HIGHWAY WORK PROPOSAL

Proposal Number: **006**

<u>STATE ID</u>	<u>FEDERAL ID</u>	<u>PROJECT DESCRIPTION</u>	<u>HIGHWAY</u>	<u>COUNTY</u>
3170-11-70	N/A	Delavan - Lake Geneva, Lake Lawn to STH 67	STH 050	Walworth

Addendum No. 01
ID 3170-11-70
Revised Sheet 15
June 3, 2025

Replace paragraph 2 with the following:

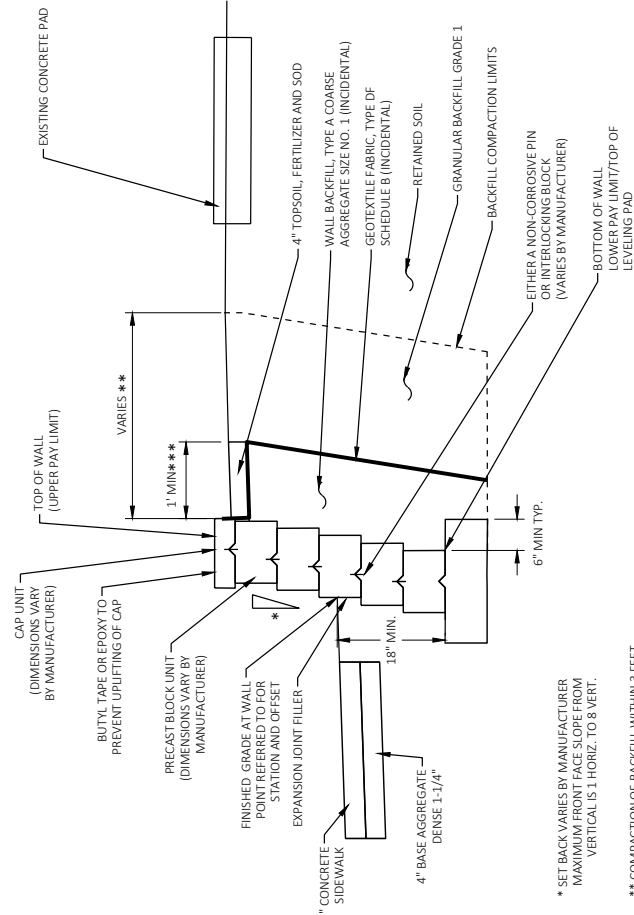
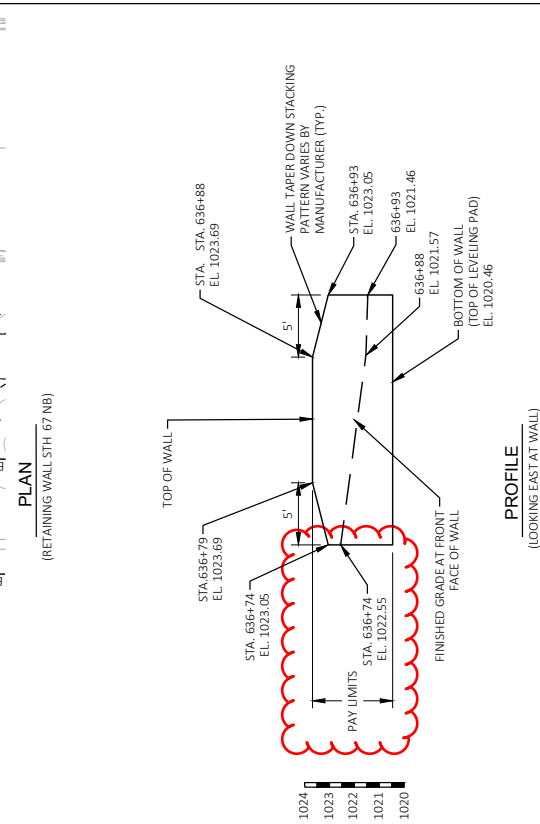
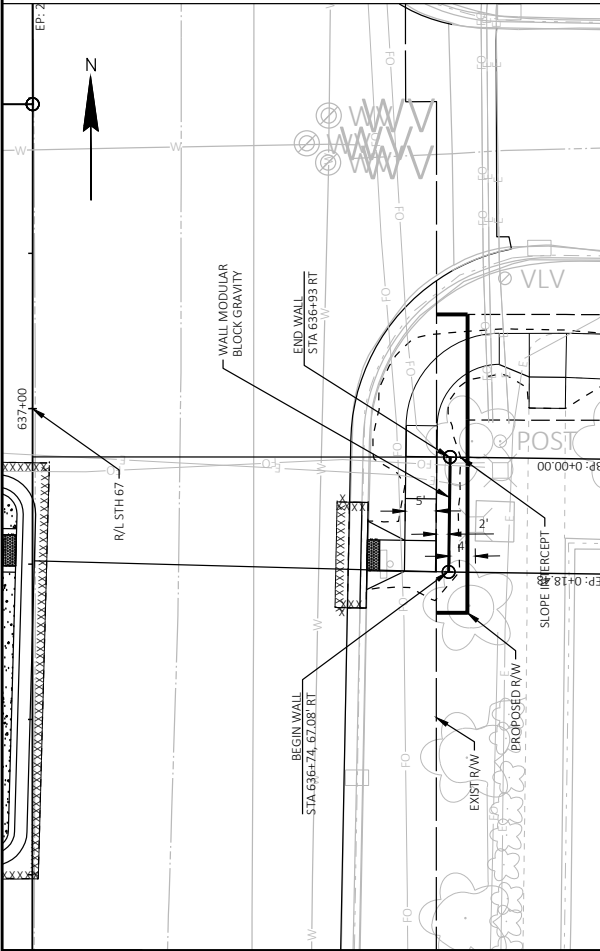
(3) For traffic signal faces: furnish signal housings, visors, LED modules, backplates, and cut away or tunnel type visors as the plans show. The visors shall be a dull black.

Addendum No. 01
ID 3170-11-70
Revised Sheet 212
June 3, 2025

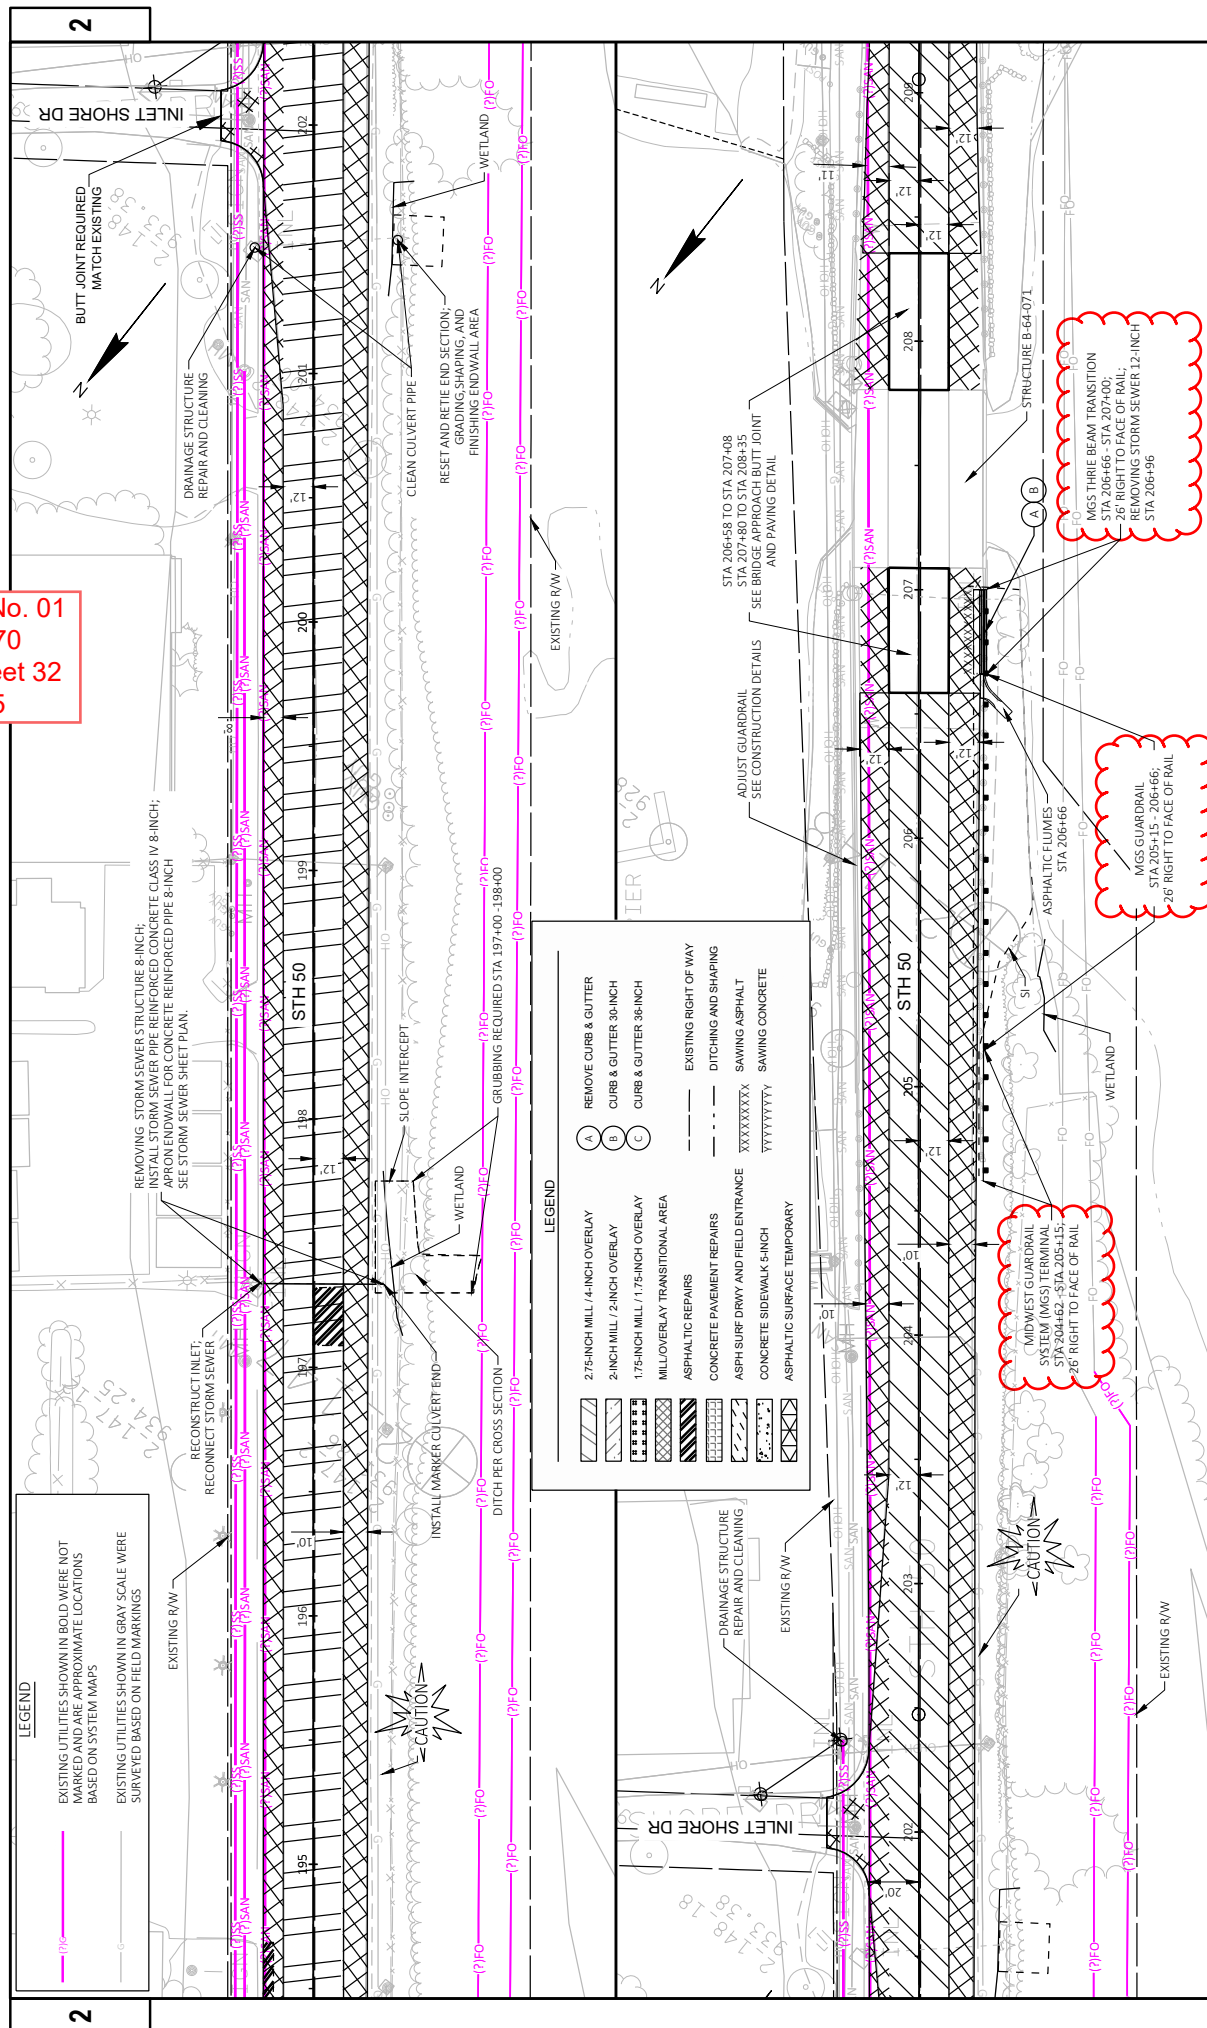
* SET BACK VARIES BY MANUFACTURER
MAXIMUM FRONT FACE SLOPE FROM
VERTICAL IS 1 HORIZ. TO 8 VERT.

**** COMPACTION OF BACKFILL WITHIN 3 FEET OF THE BACK FACE OF THE WALL SHOULD BE ACCOMPLISHED USING LIGHTWEIGHT COMPACTION DEVICES. BACKFILL LIFTS SHALL BE NO MORE THAN 8 INCHES IN DEPTH AFTER COMPACTION**

*** WITHIN 1 FOOT BEHIND THE BACK FACE OF THE WALL SHALL BE WALL BACKFILL TYPE A
COMPACT WALL BACKFILL TYPE A WITH AT LEAST 3 PASSES

NOTE: THE COLOR AND SURFACE
TEXTURE OF THE BLOCK SHALL BE TAN
OR SANDSTONE WITH A SPLIT FACE
